CITY OF WINFIELD
PUTNAM COUNTY, WEST VIRGINIA

CONTRACT NO. 1 – WASTEWATER TREATMENT PLANT IMPROVEMENTS

ADDENDUM NO. 3

CITY OF WINFIELD PUTNAM COUNTY, WEST VIRGINIA WWTP IMPROVEMENTS HEADWORKS ELEVATIONS	SHEET No. 3D

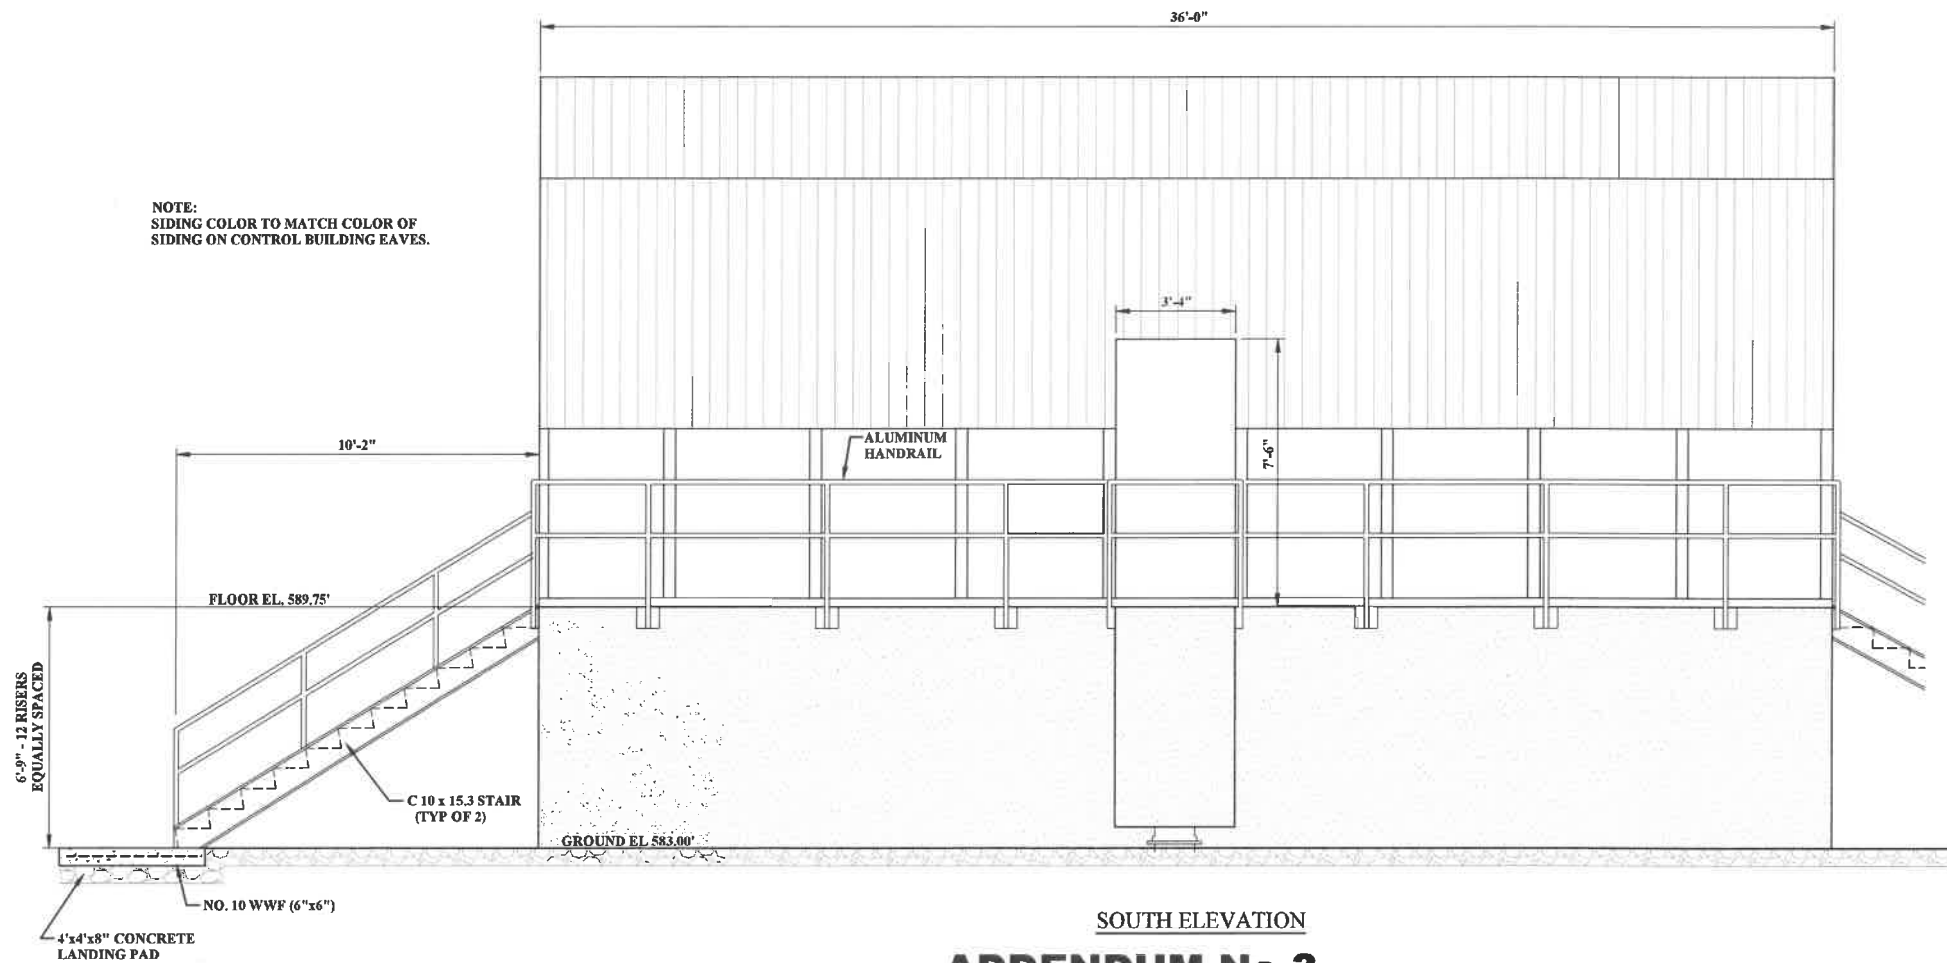
- 25. Question:** Please detail headworks stop plates and/or frame

37. Question: Drawing 3C shows a carport over the headworks. Please provide dimensions and South/West views so we can determine takeoff.

Answer: See Sheet 3D attached to this addendum.

Answer: See Sheet 3D attached to this addendum.

DOOR NOTES:

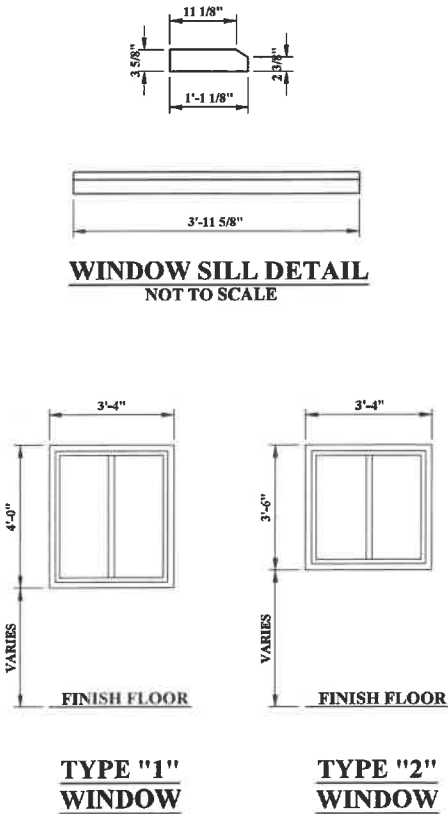
4. Question: On note 2 on Sheet 6G, what is meant by double insulation?

5. Question: Note 2 on Sheet 6G states that all doors are to receive push pull plates. In Section 087100 Part 3.8A, there is a HDW set 1 listed. Are the interior doors to receive HDW set 1 and the interior receive push/pulls in lieu of the lockset?

8. Question: There are 2 double door openings. Section 087100 Part 3.8.A does not include hardware for a complete double door opening.

Answer: Note 1 on Sheet 6G has been revised. A copy of revised Sheet 6G is attached to this Addendum.

Answer: Sheet 6G and 7G along with Specification 087100 "Door Hardware" have been revised to clarify the door hardware required. Revised Sheet 6G and 7G as well as revised Specification 087100 are attached to this Addendum.

Answer: Sheet 6G and 7G along with Specification 087100 "Door Hardware" have been revised to clarify the door hardware required. Revised Sheet 6G and 7G as well as revised Specification 087100 are attached to this Addendum.

SITE ELECTRICAL PLAN

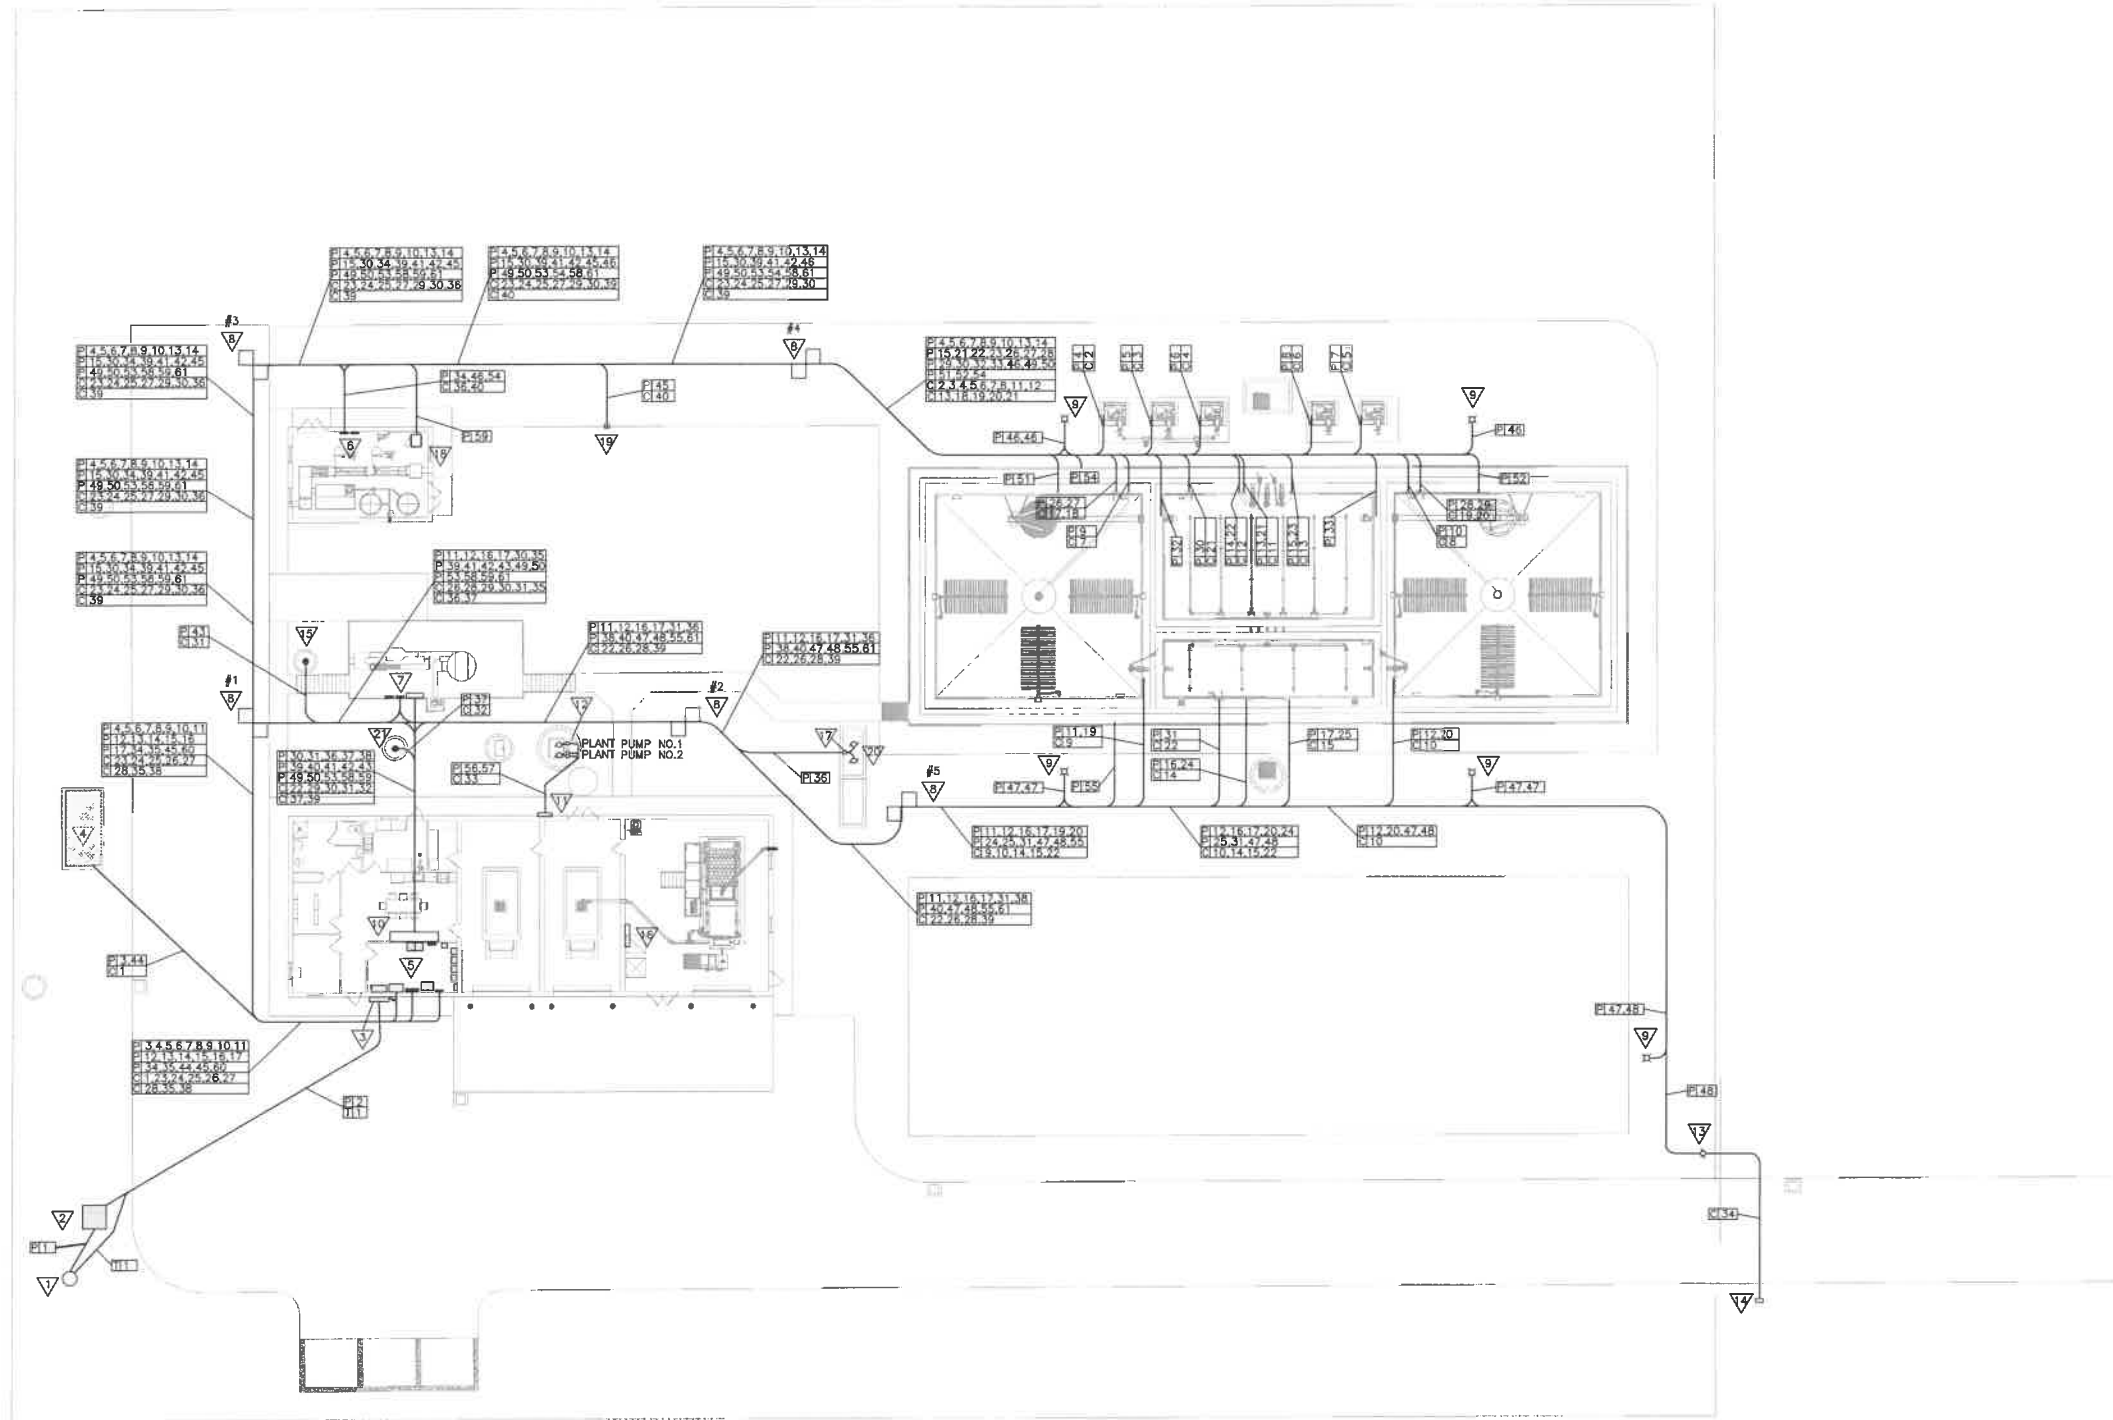
15. Question: Is access control to the gate included in Bid? If so, what are the access control system components and where are they located?

36. Question: Drawing SE1 does not have a scale. Please provide a drawing to scale in order to measure conduits, wiring, and concrete encasements for this project.

Answer: Yes. Sheet SE1 Equipment Note 14 shows the gate keypad.

Answer: Sheet SE1 has been revised and is attached to this Addendum.
